Docket Item # 1&2
BAR CASE # 2014-0026 & 0027

BAR Meeting
March 19, 2014

ISSUE: Permit to Capsulate & Certificate of Appropriateness Application for an Addition and Alterations

LOCATION: 707 Devon Place

PHYSICAL IMPROVEMENTS SURVEY

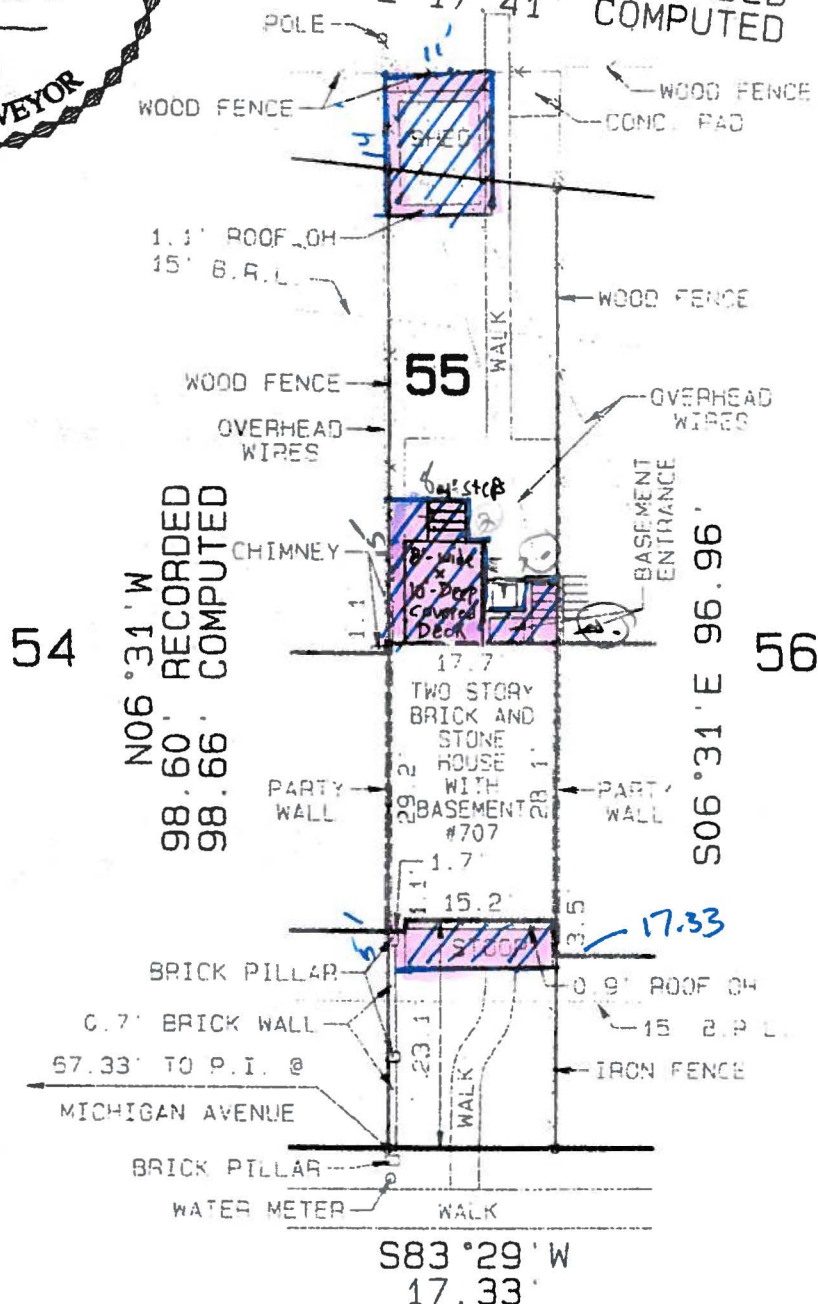
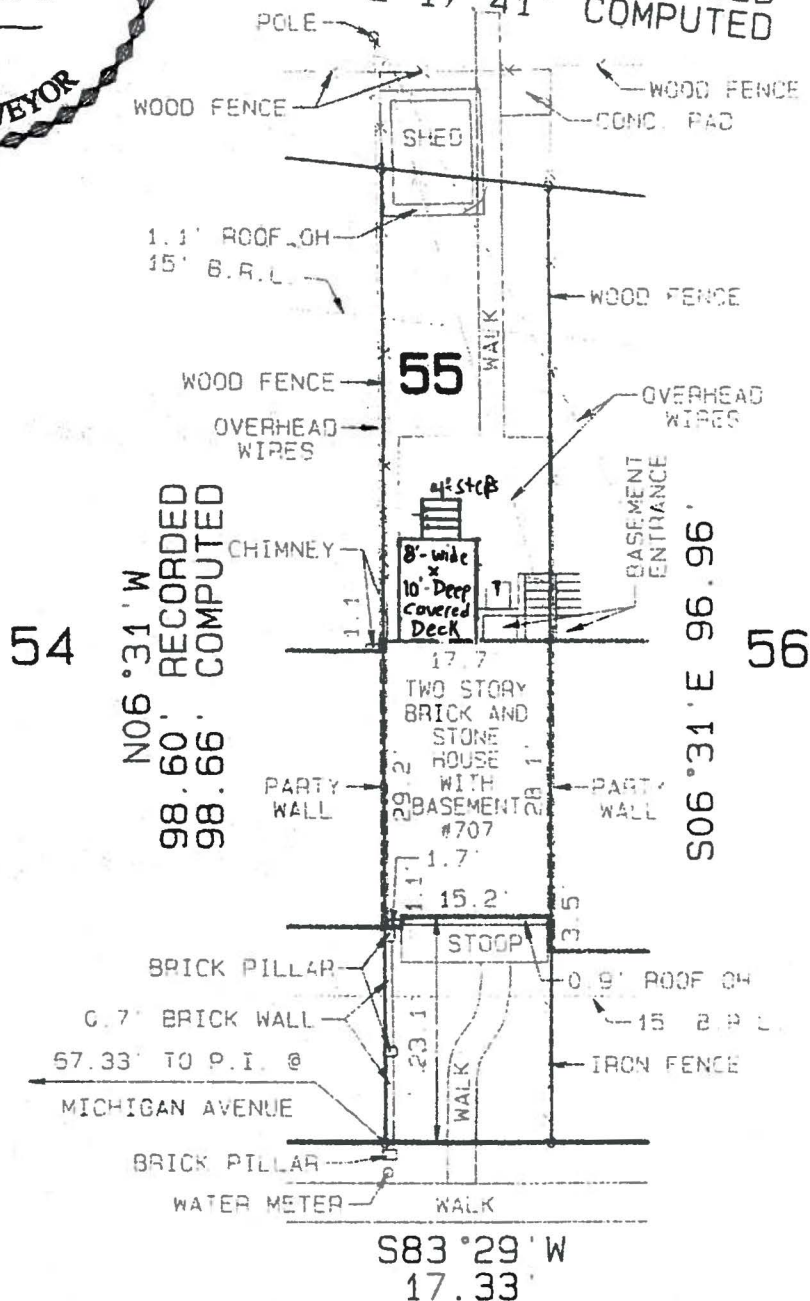
- F-1 Staff recommends the applicant schedule a meeting to discuss the proposed improvements to the property.
- C-1 Existing and proposed shed are not located completely on the subject property.

- C-2 The subject property is a through lot with frontage on Devon Place and Bernard Street. Existing and proposed shed are located forward of the front building wall and across the front property line facing Bernard Street. Applicant must locate the shed on the subject property and request a variance to locate it in the required front yard and forward of the front building wall. Open space will need to be recalculated once the shed is relocated.

- C-3 The dimensions on the plat of the proposed shed and the screened porch appear different from proposed plans. All plans must be consistent.
- C-4 Proposed shed is not a direct replacement of the existing structure. The proposed shed is 9.2' to the ridge and is taller than the existing shed.

Staff is working separately with the applicant to correct the zoning violations. While the proposed shed construction must be deleted from the current BAR application, the owner may seek a variance from the Board of Zoning Appeals, and a separate Certificate of Appropriateness application from the BAR in the future, to reinstall a shed in the front yard and construct a new front yard fence within their property.
